Name: Horizon Park East - Final Plan & Plat

FILE: 2-93 (2)
DATE: June 18, 1993
STAFF: Kathy Portner
REQUEST: Horizon Park East--Final Plat and Plan and ROW Vacation
LOCATION: South of G Road, West of Horizon Drive
APPLICANT: Bob Bray and Wayne Beede

RESPONSE TO REVIEW COMMENTS

TITLE HEADING: Change in Approved Golf Cart
Easement - Horizon Park East

SITE PLAN HORIZON PARK EAST SUBDIVISION

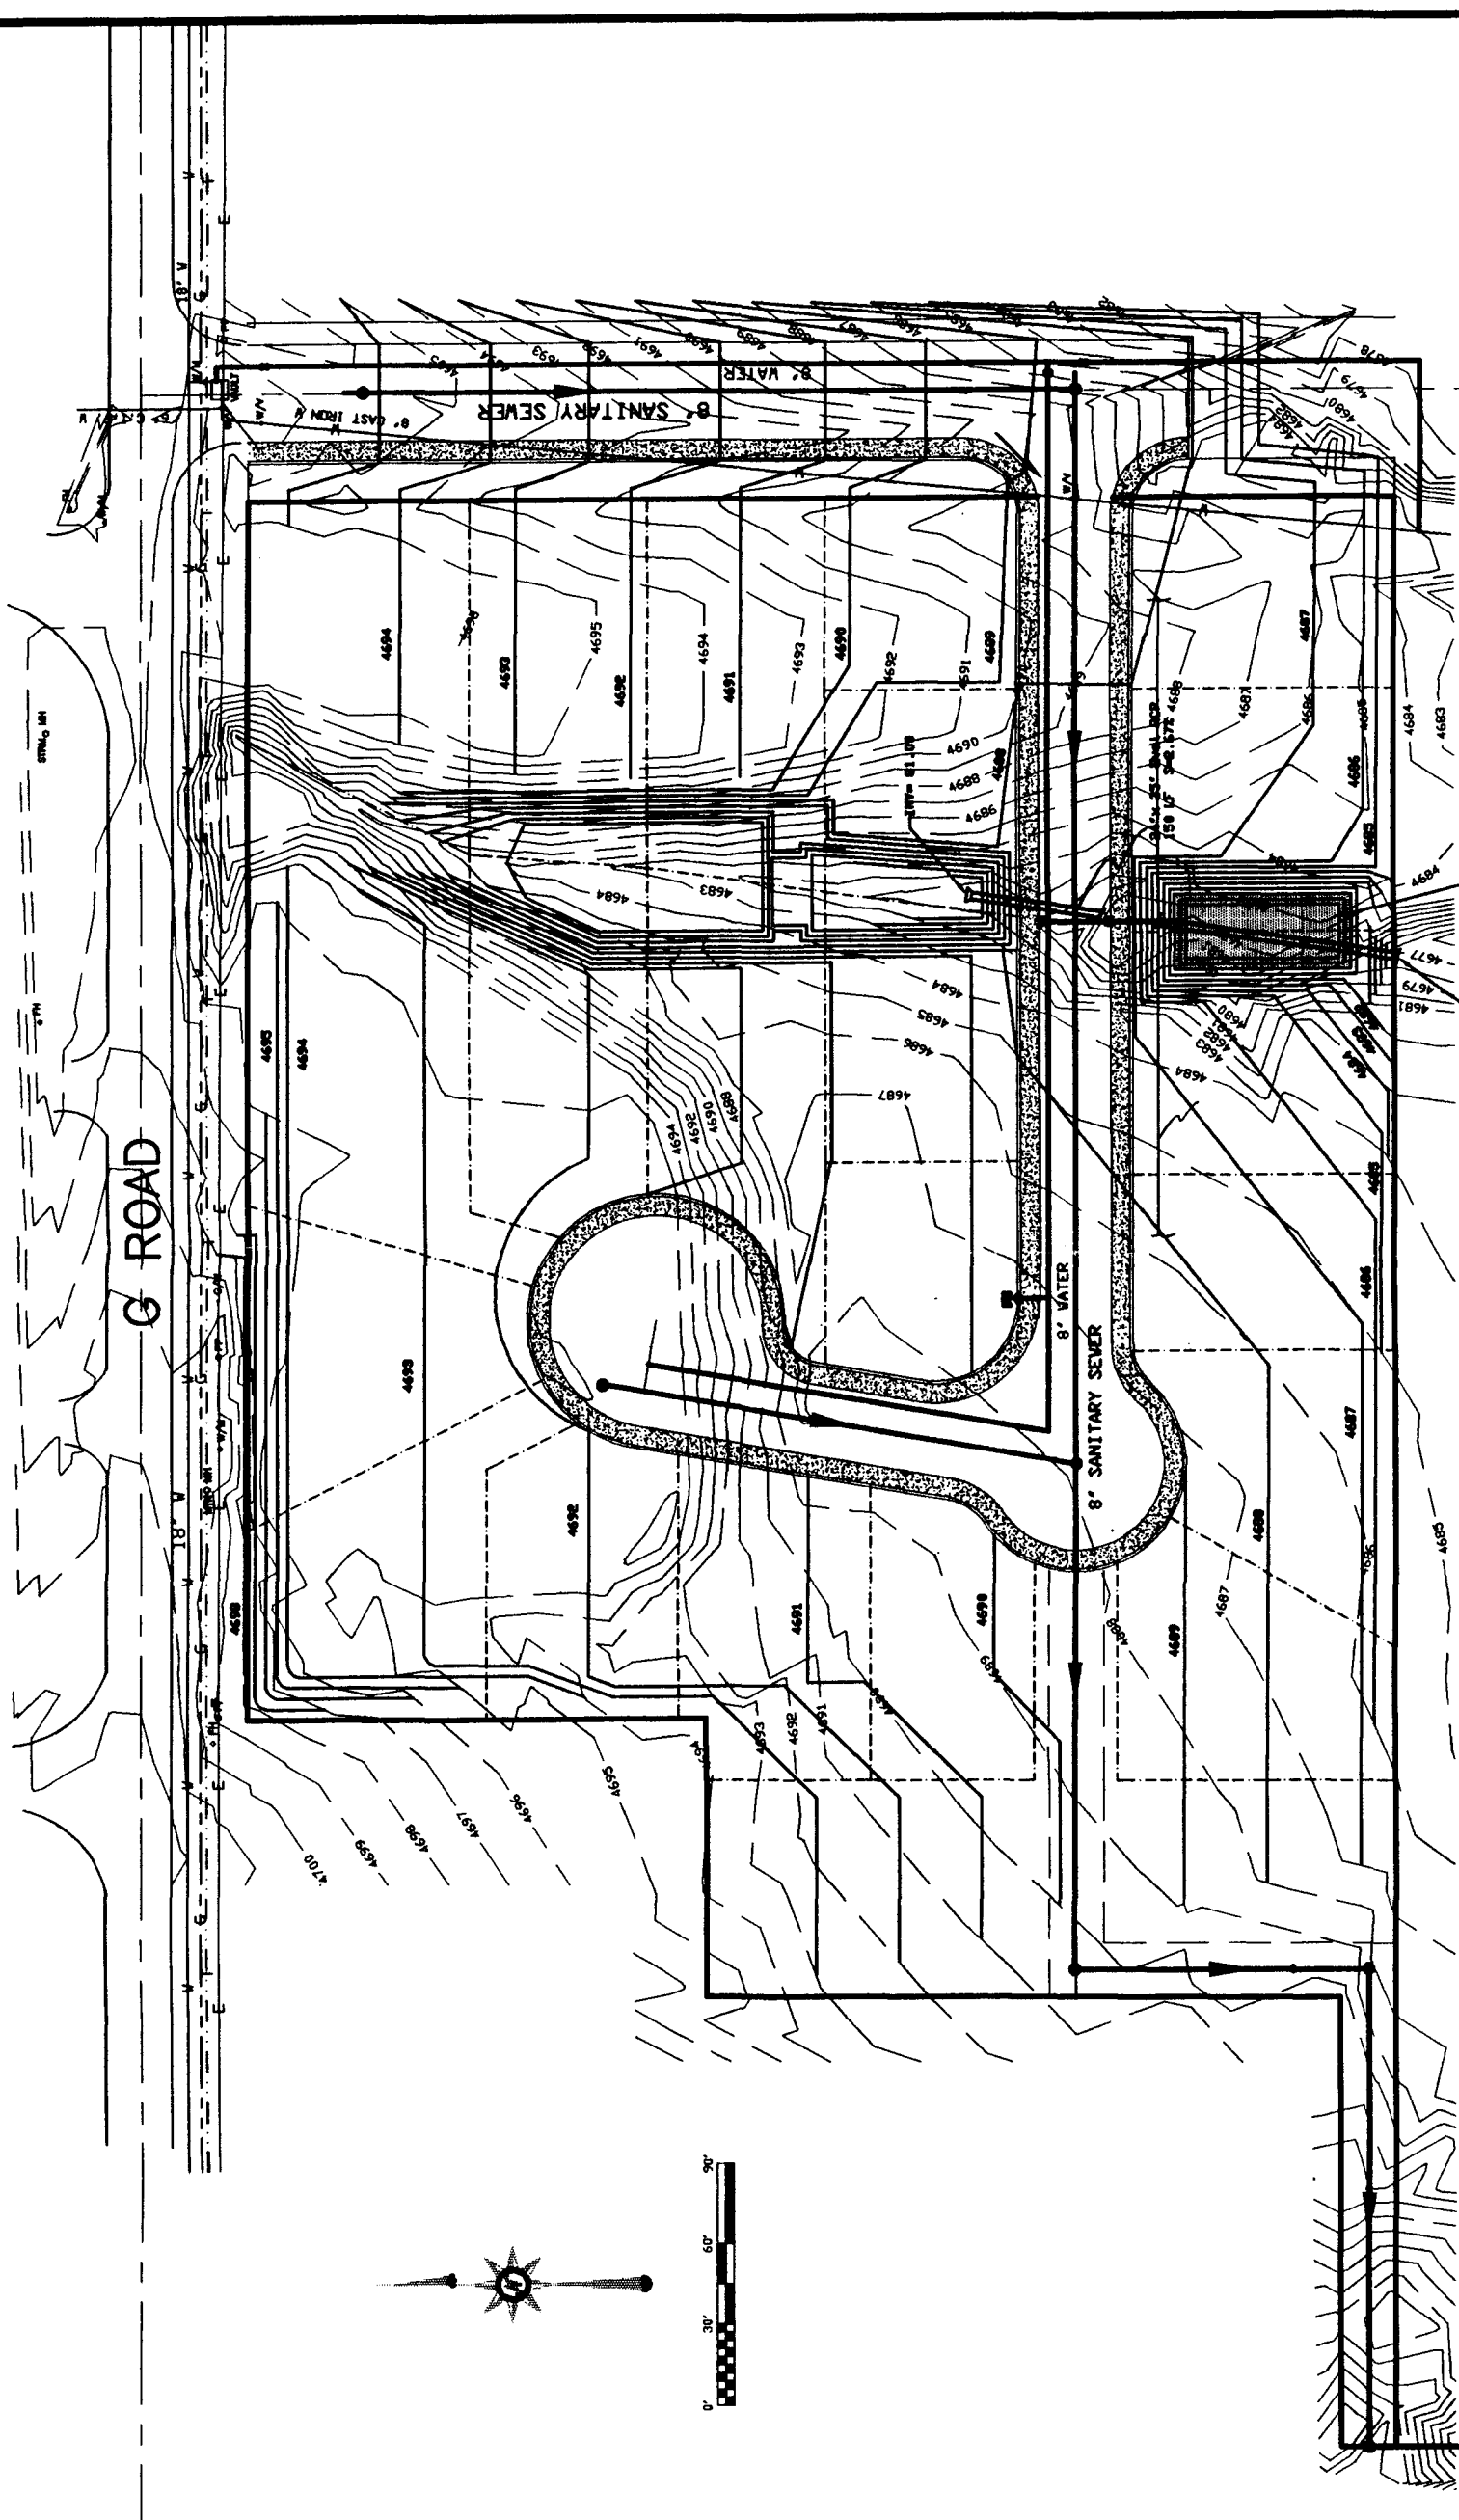
3. Submit a site plan showing the proposed building envelopes for each lot. It is confusing as to when the 10' or 15' rear yard setback applies.
4. How will the golf cart easement be developed and maintained? Will lots 16 and 17 have golf carts going along their driveways?

6. The covenants refer to allowing only detached units. The narrative indicates there may be common wall units. There is also a reference to the setback requirements to be to City of Grand Junction standards. It should probably reference the approved setbacks as indicated on the plat or recorded site plan.

- 4) The golf cart easement will be graveled. Lots 16 and 17 will have golf carts going along their driveways.
- 6) Covenants refer to only detached units and the final engineering package will show only detached units. The covenants will be changed to reference the site plan for approved setbacks.
